PARTS SERVICE BULLETIN

No. G.A.7.

A MODELS - ENGINE MOUNTING.

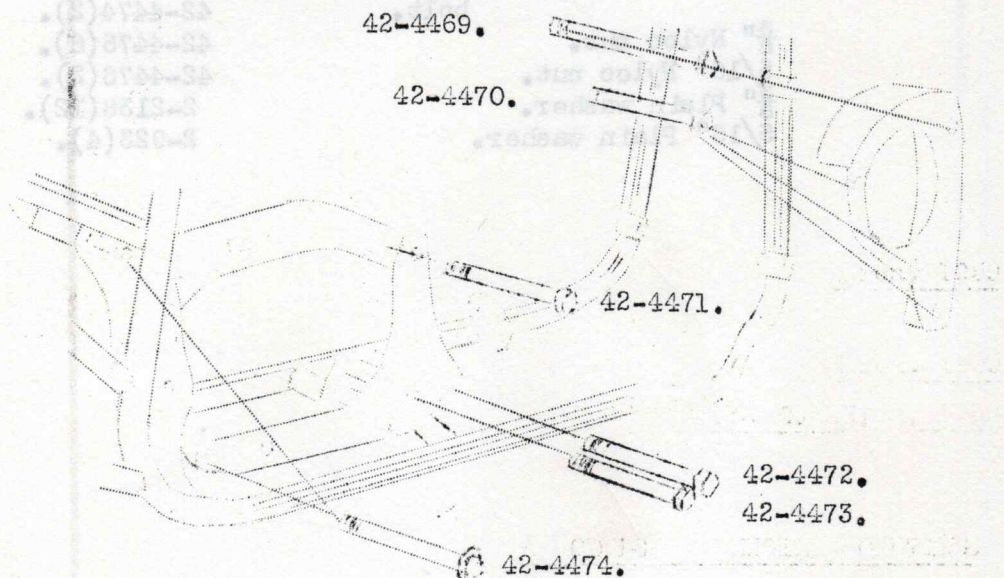
To improve engine mounting, the fixing studs have been replaced by bolts as indicated in the sketch.

Self-locking nuts are employed, and plain washers are fitted beneath the bolt heads and the nuts, except in the case of the front engine bolt, No. 42-4469, which retains two spring washers and special nut, Part No. 67-1292.
